PIVOT ARCHITECTURE

ADDENDUM # 5

Project: **Klamath Community College Childcare Learning Center (2331.00)**

Date: September 4, 2025

L301

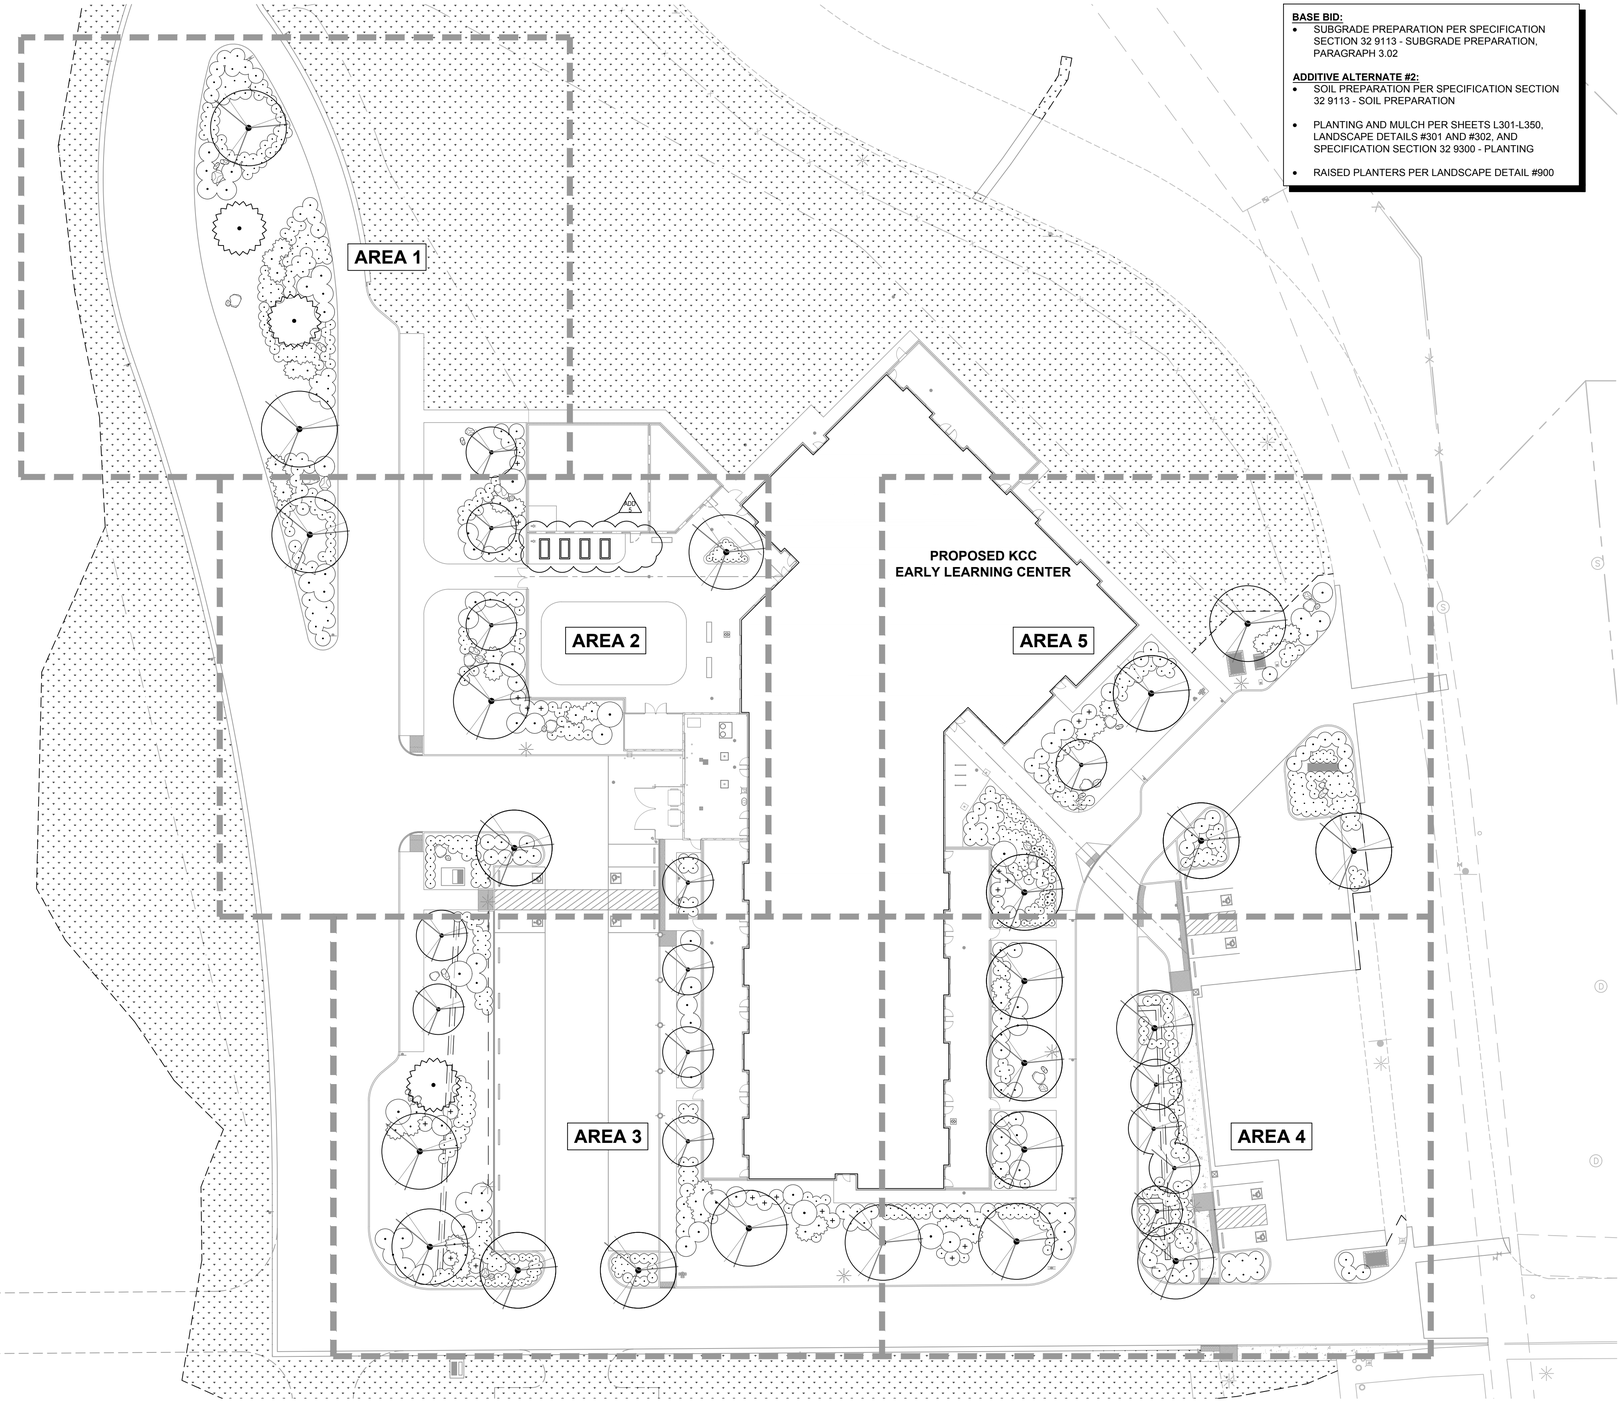
3.6. L301 OVERALL PLANTING PLAN & SHEET KEY

3.6.1. Removed (1) raised planter box.

L320

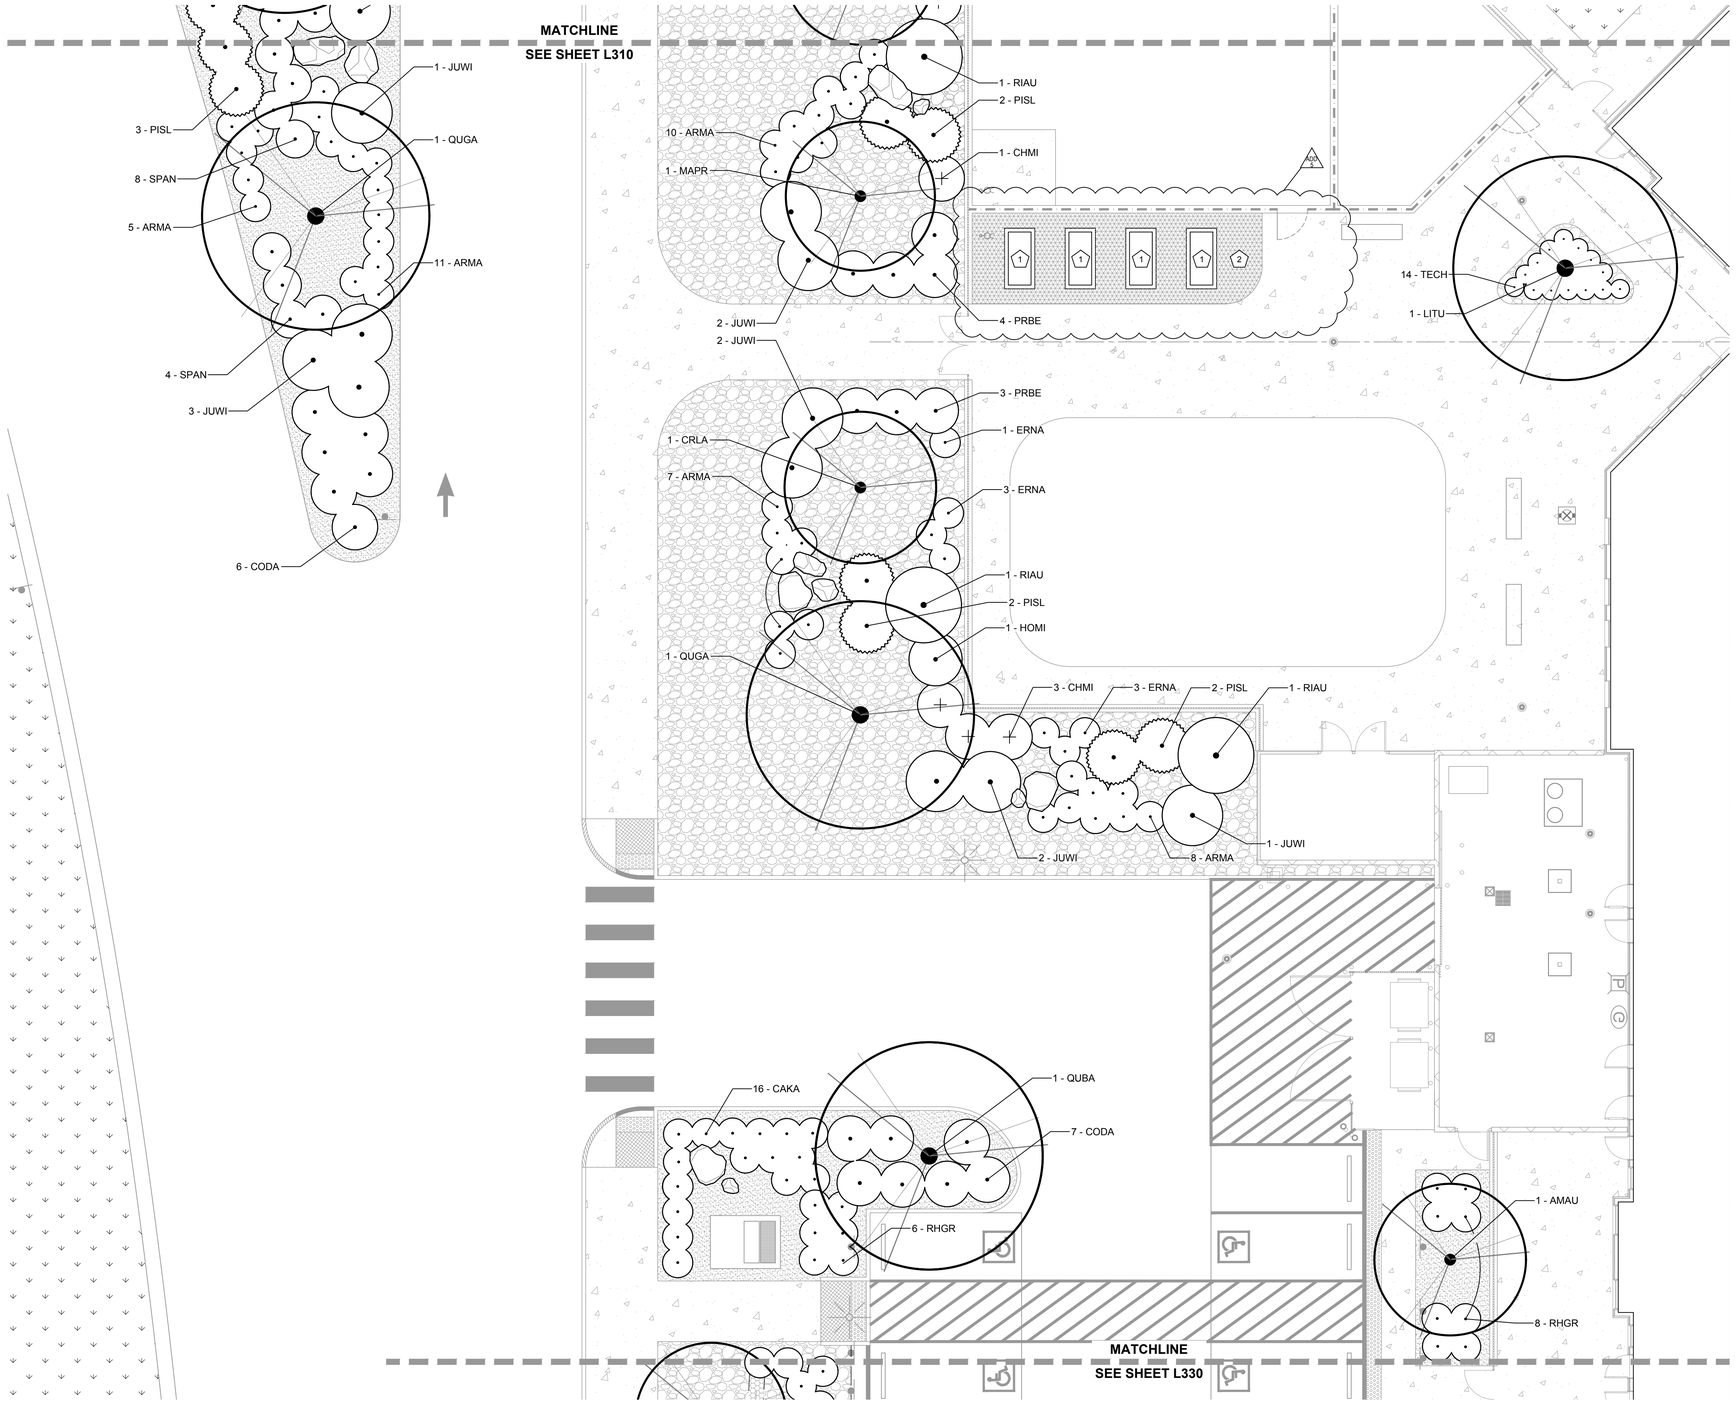
3.7. L320 PLANTING PLAN – AREA 2

3.7.1. Removed (1) raised planter box.

1 SITE PLAN
1" = 40'-0"

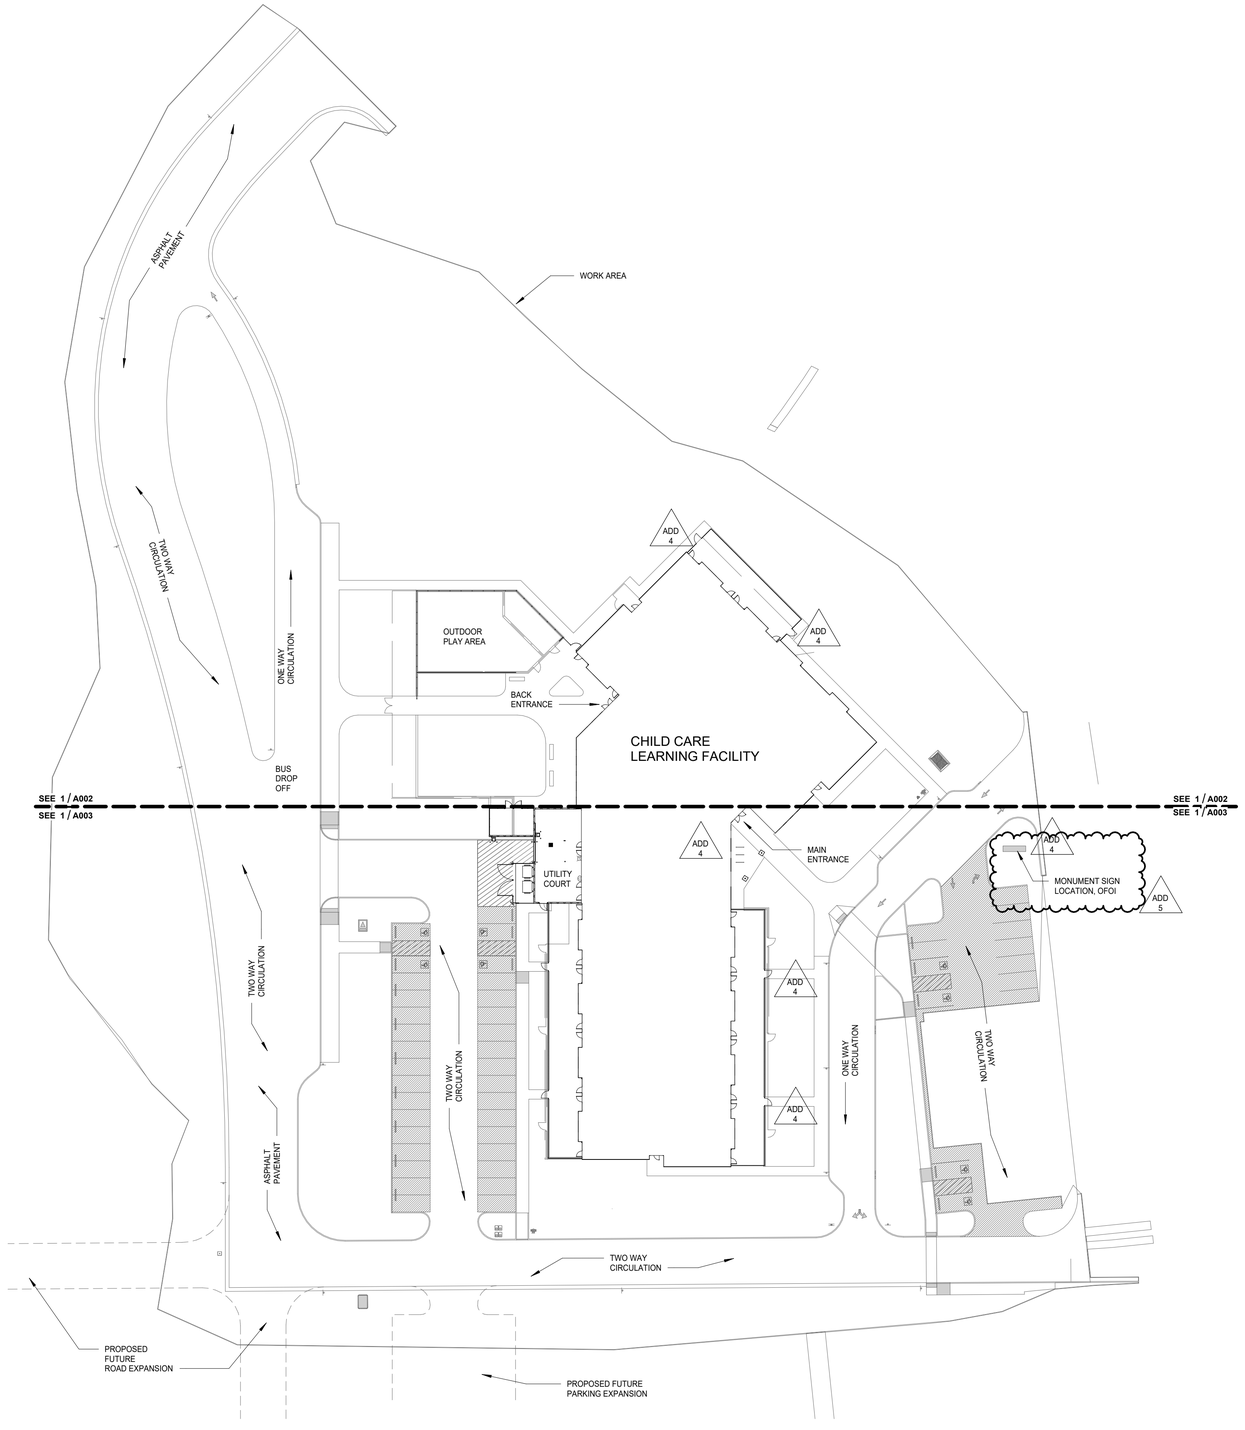
3.10. A001 SITE PLAN

3.10.1. REVISED, added back in the monument sign location, OFOI

1 FLOOR PLAN - SECTOR A
1/8" = 1'-0"

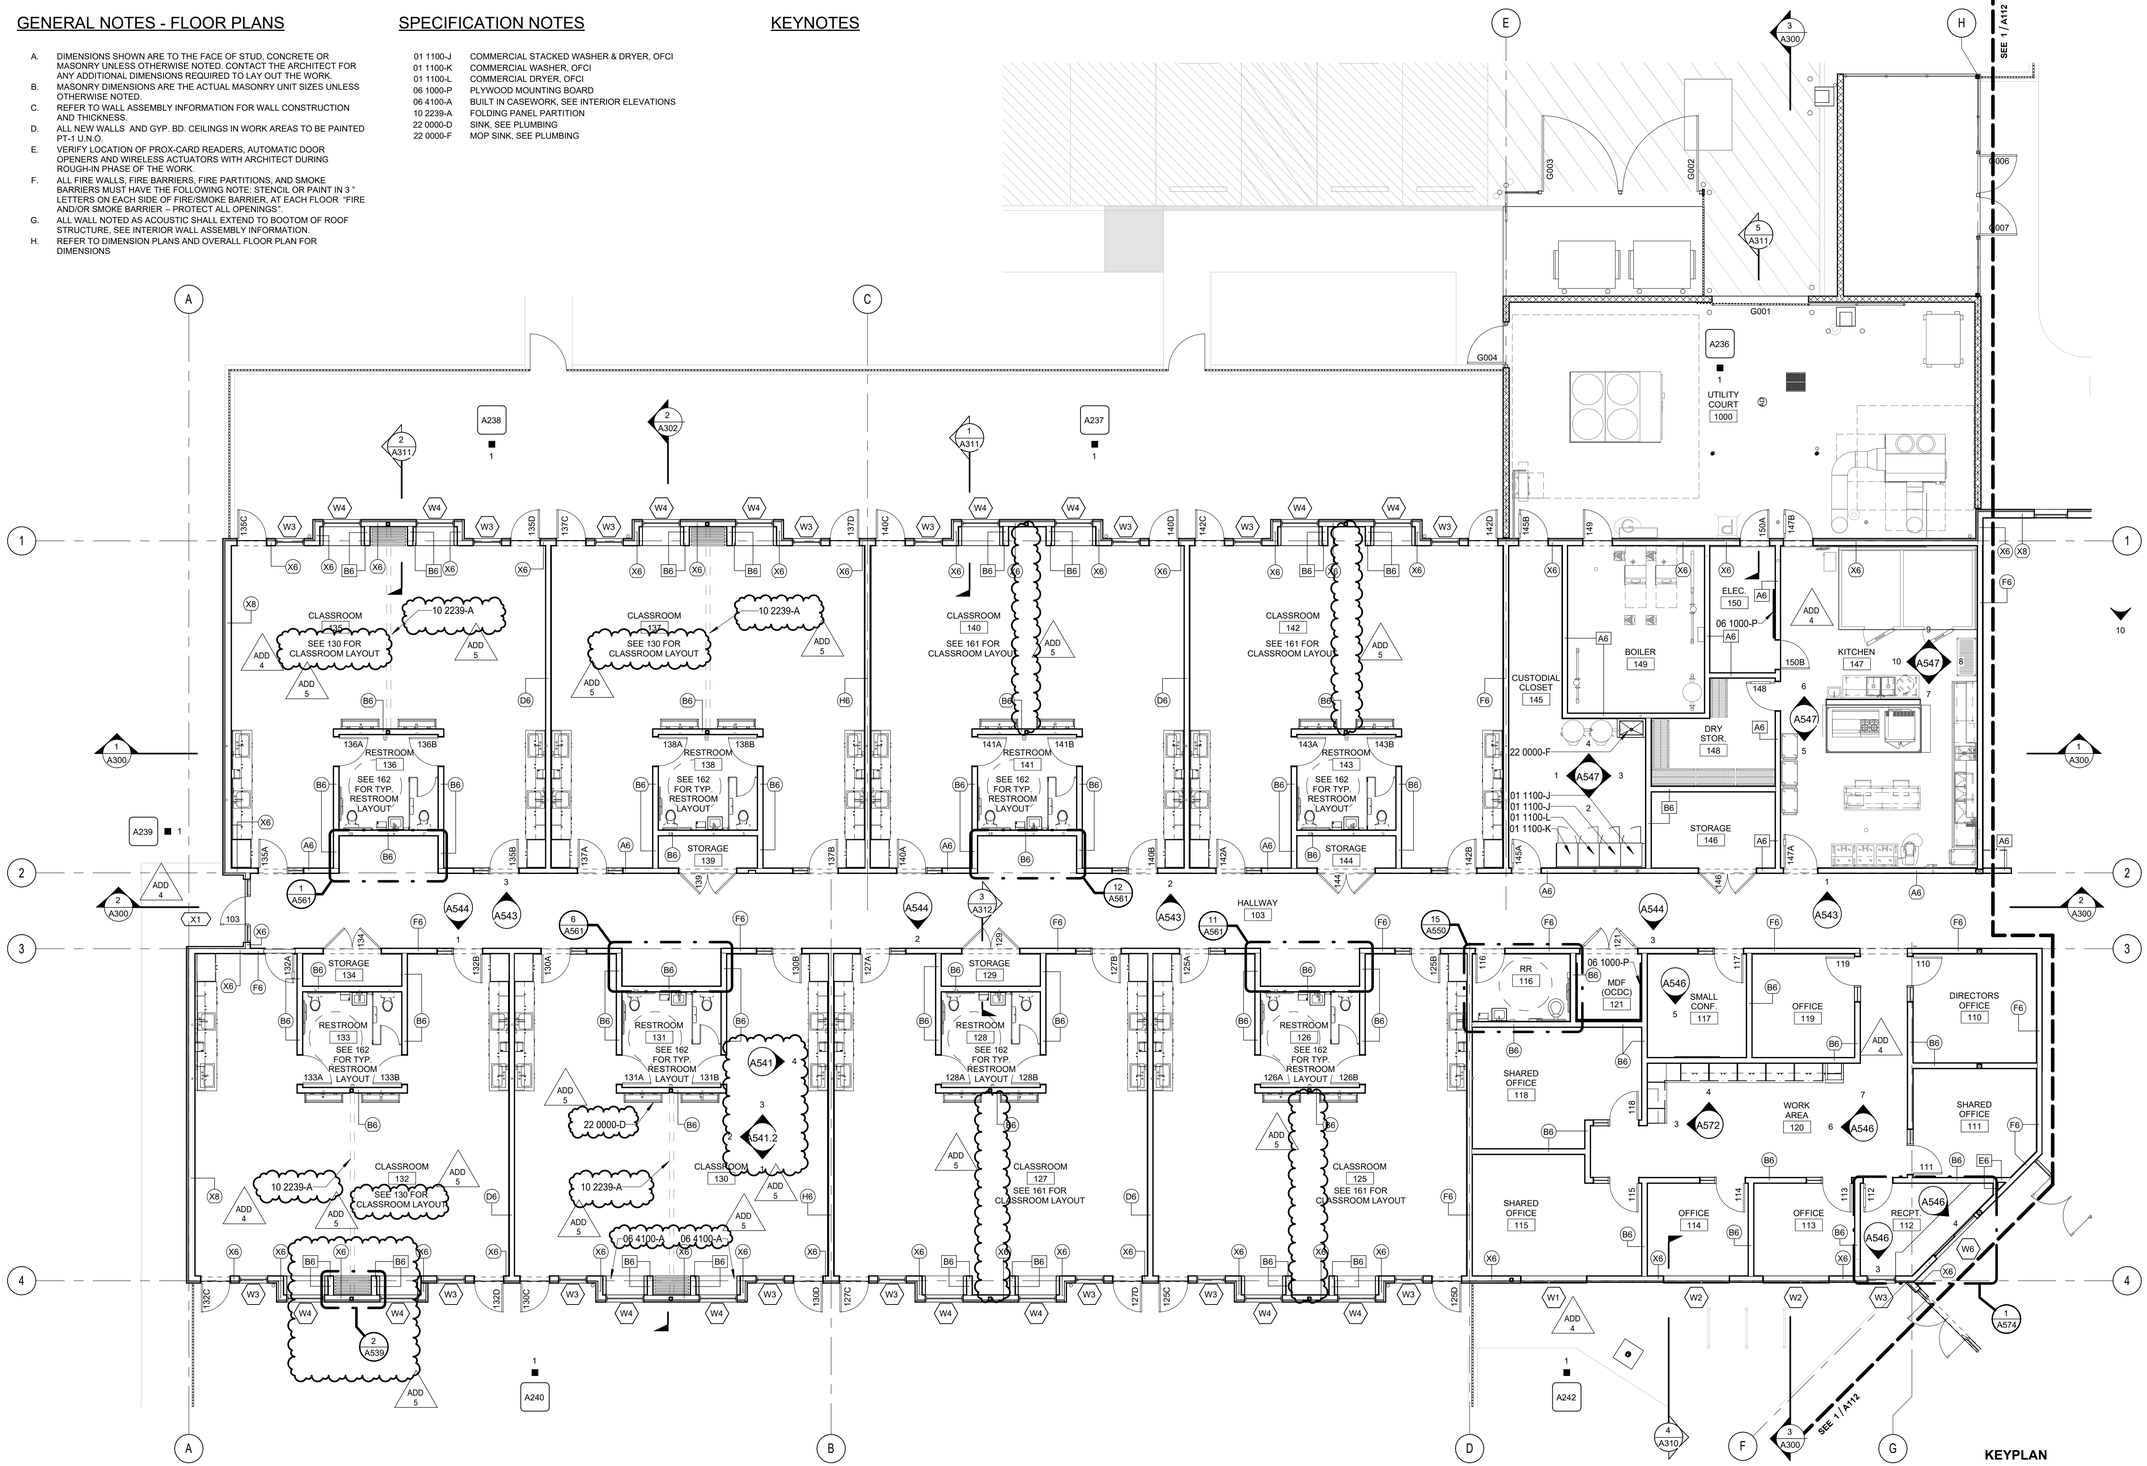
3.12. A111 FLOOR PLAN SECTOR A
- 3.12.1. REMOVED folding panel partitions from all classrooms except classrooms 135, 137, 132, 130
- 3.12.2. ADDED detail call out – 2 A539 – Plan detail @ Operable Partition
- 3.12.3. CHANGED note in classrooms 135, 137, 132, 130
- 3.12.4. ADDED elevation views for Classroom 130 (TYP for classrooms with operable partition)
- 3.12.5. ADDED Keynotes to Classroom 130
